**PROCUREMENT SERVICES
ADDENDUM**

Date of Notice:	1/27/2025
Solicitation No.:	IB-010-25
Title:	HSC Restroom Renovations
Addendum No.:	2

UofL HSC RESTROOM RENOVATIONS

55A-E100

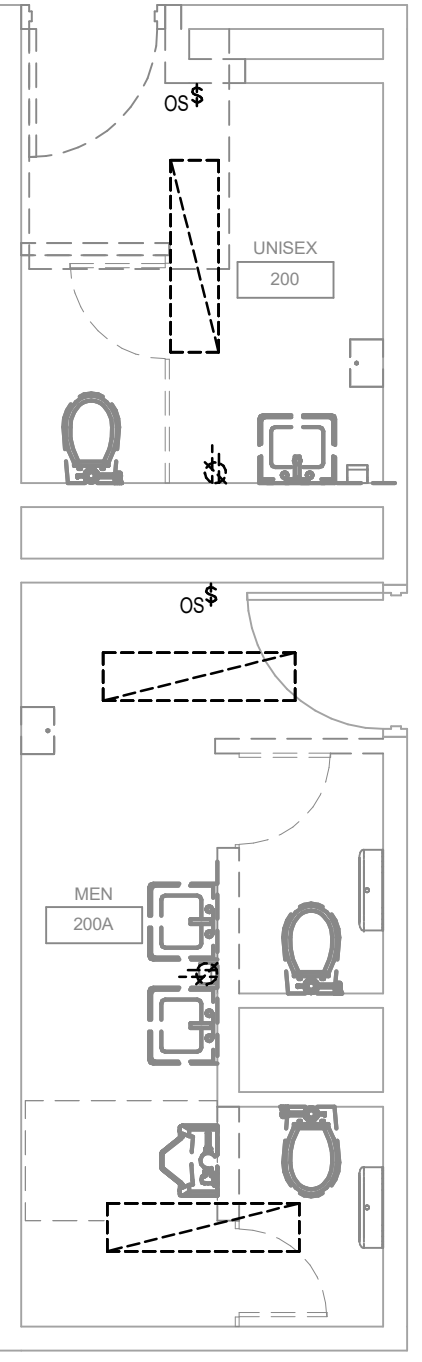
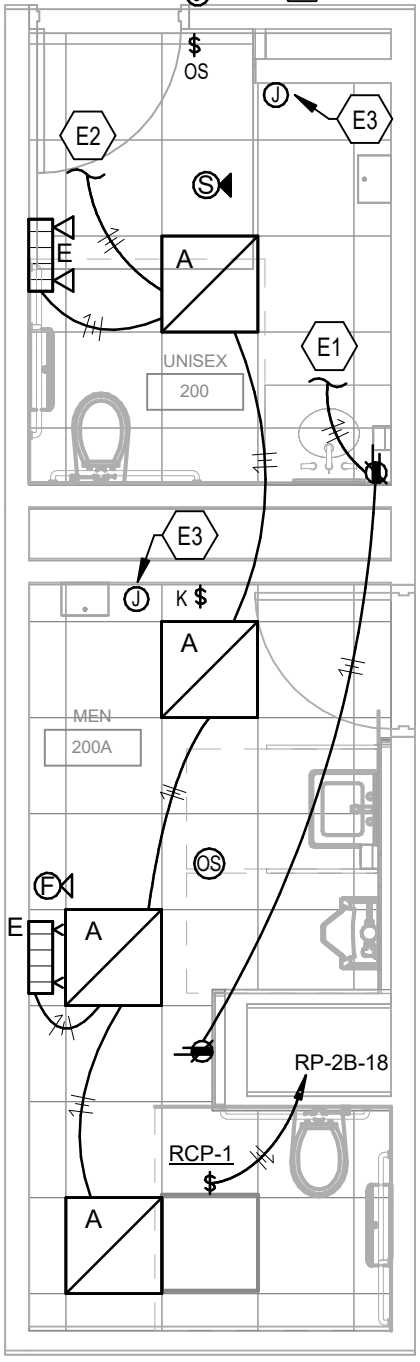
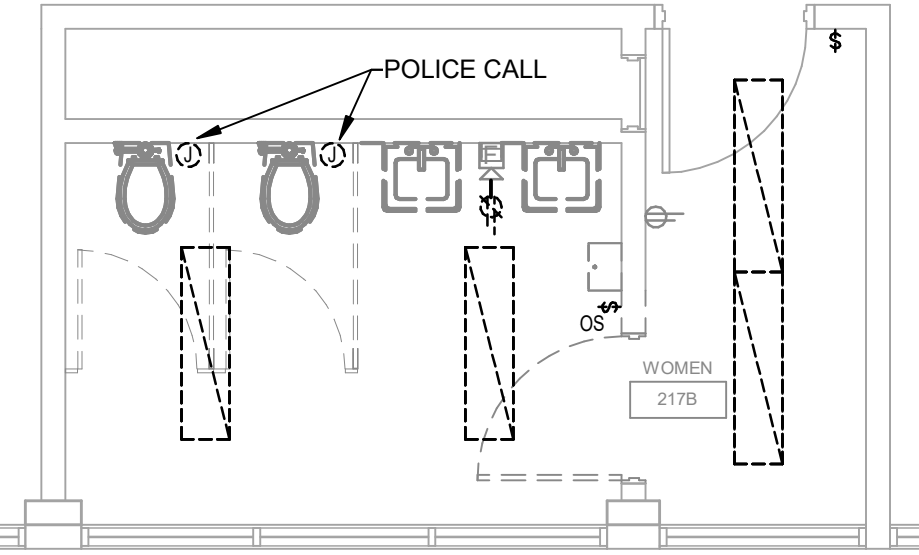
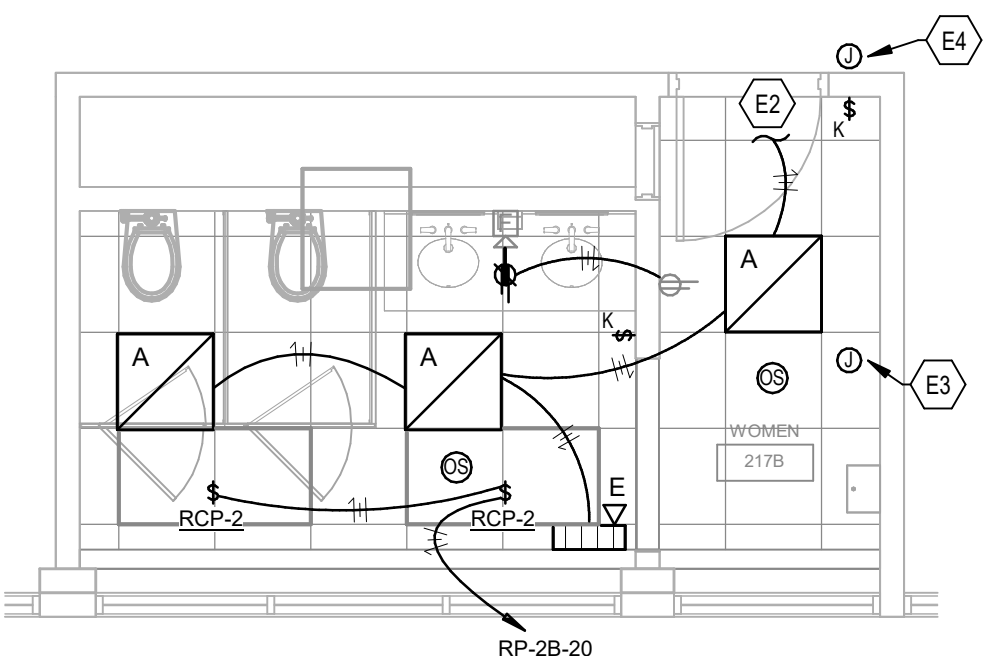
1. On sheet E100, keynote E4 says to provide new police call sounder station and tie into existing system. Coordinate exact requirements with UofL. Our electrical sub is asking where these are supplied from. They are wanting to make sure that they quote the ones that UofL requires.

University Response: Please see the below attached drawings.

- E1 ROUTE # OF #12 CONDUCTORS IN 3/4" CONDUIT TO EXISTING RECEPTACLE CIRCUIT SERVING THIS AREA.
- E2 ROUTE # OF #12 CONDUCTORS IN 3/4" CONDUIT TO EXISTING LIGHTING CIRCUIT SERVING THIS AREA.
- E3 PROVIDE NEW BACKBOX, AND RACEWAY WITH PULLSTRING TO NEW POLICE CALL FULL STATION. COORDINATE EXACT REQUIREMENTS WITH UOFL.
- E4 PROVIDE NEW BACKBOX, AND RACEWAY WITH PULLSTRING TO NEW POLICE CALL SOUNDER STATION LOCATION. COORDINATE EXACT REQUIREMENTS WITH UOFL.
